REVISED RESPONSE TO REQUEST FOR ADDITIONAL INFORMATION

APR1400 Design Certification

RAI No.: 393-8432

SRP Section: 19.03 – Beyond Design Basis External Event (APR1400)

Figure 5-3 Containment Pressure and Temperature for Full Power

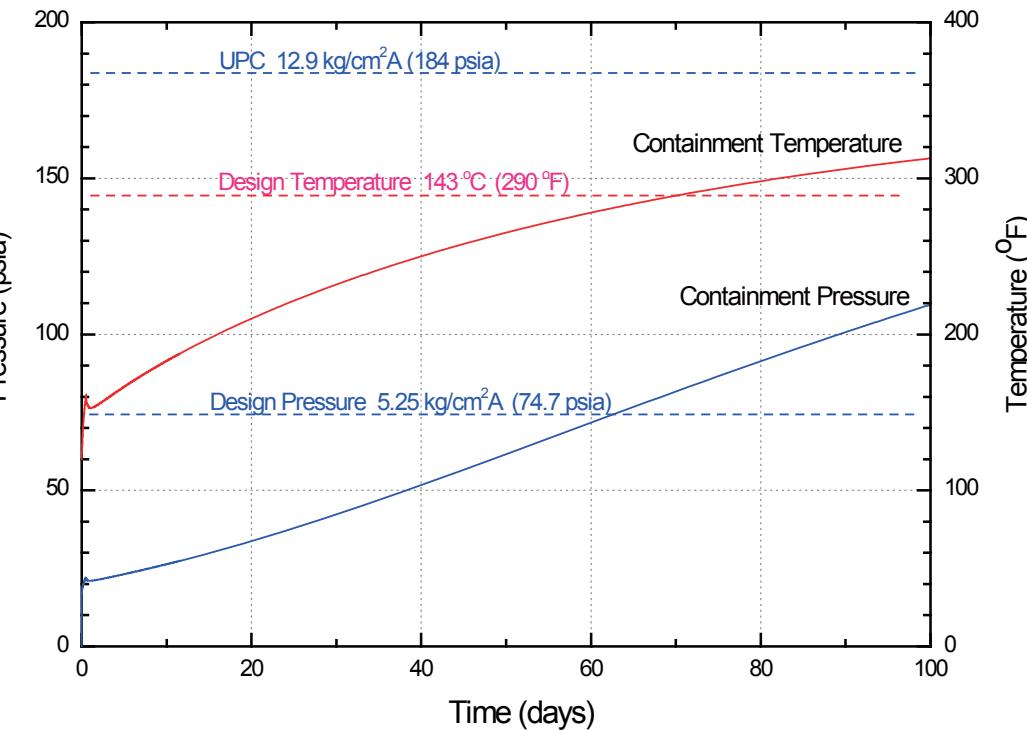
This will be replaced with "N" and "O" of the following page.

Figure 5-4 Containment Pressure for Loss of RHR (Mode 5)

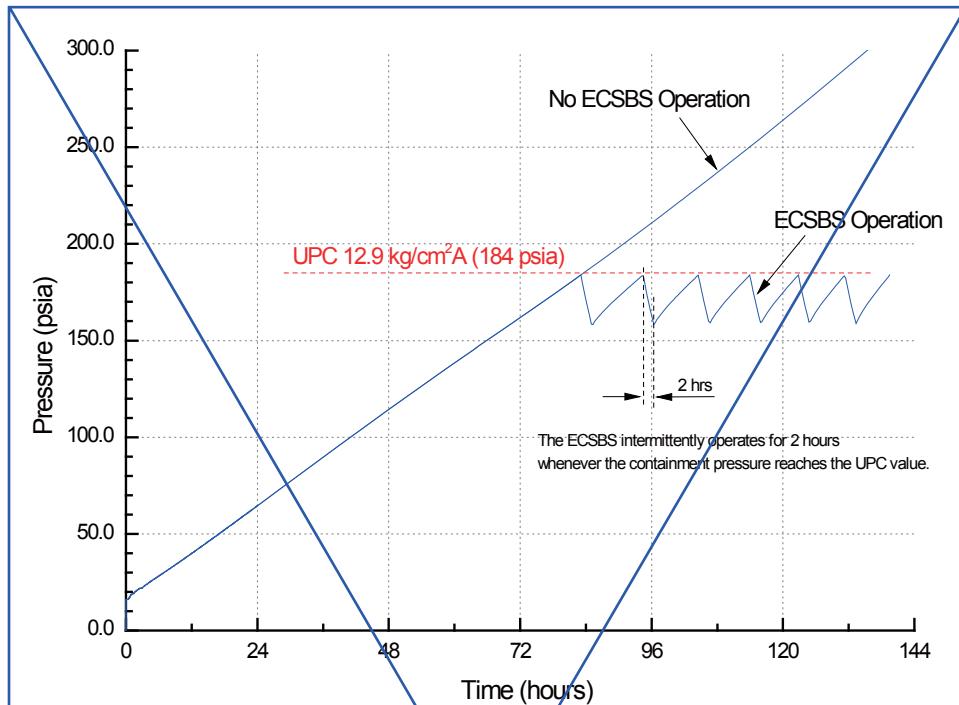
GOTHIC analyses are performed for evaluation of the containment pressure and temperature responses following loss of RHR in mode 5. Figure 5-4 shows that the containment pressure reaches the UPC value in about 3.5 days without ECSBS operation, but with the intermittent operation of ECSBS, containment

Figure A-26 Liquid Fractions of Upper Plenum and Core Top

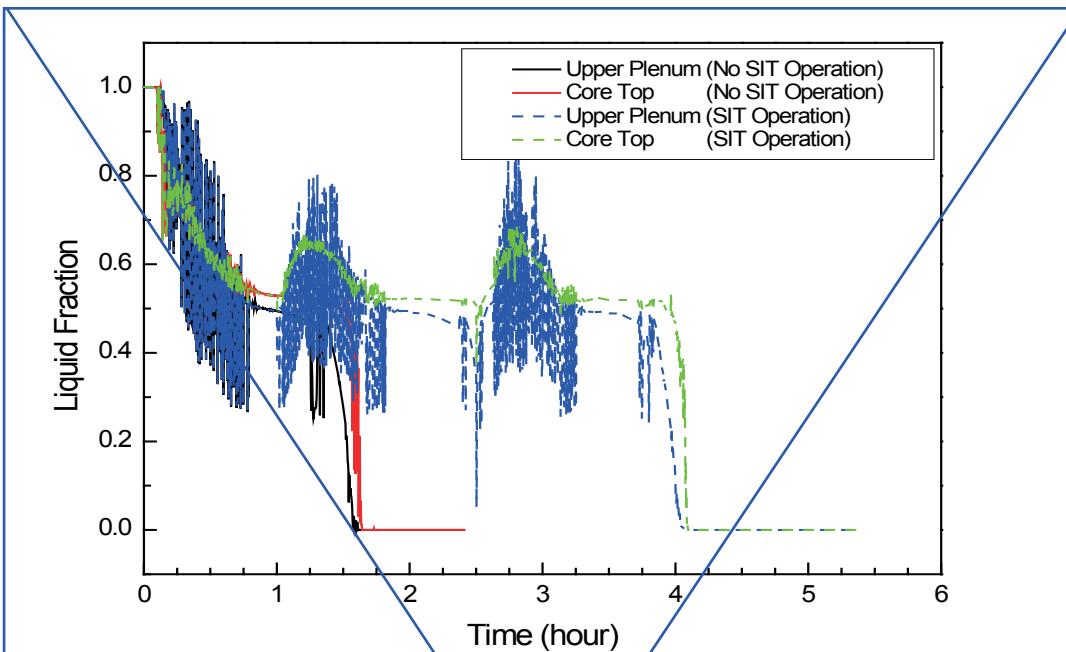
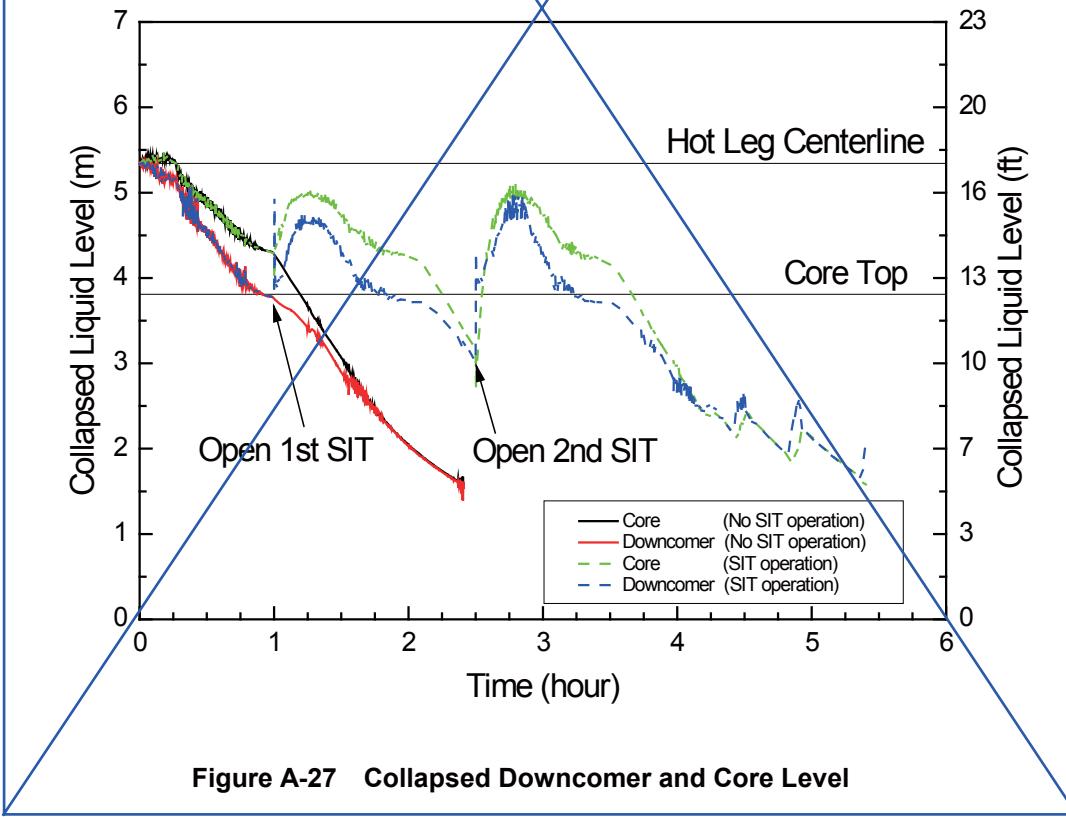
- a. Please document in Section 19.3 of the DCD how the safety injection tanks (SITs) can keep the core covered assuming the RCS is vented via the pressurizer given possible pressurizer surge line flooding. Surge line flooding following an extended loss of decay heat removal (DHR) may negate the elevation head necessary for SIT flow. Based on the shutdown evaluation report, the staff understands "With the earliest nozzle dam installation occurring at 4 days after shutdown, the decay heat present would require approximately 481 L/min (127 gpm)".

All discussions regarding shutdown mitigating strategies are removed from DCD Tier 2 section 19.3 and Technical Report APR1400-E-P-NR-14005-NP and instead a COL item for the COL applicant to develop shutdown risk process and procedures consistent with NEI 12-06 guidance, [revision 2](#) for shutdown modes is added, as indicated on the attached markup.

In the response to RAI 393-8432, question 19.03-13, revision 1, however, there are still references to using the SITs to keep the core covered during the shutdown operations with SGs not available. These references are removed as indicated on the attached markup.
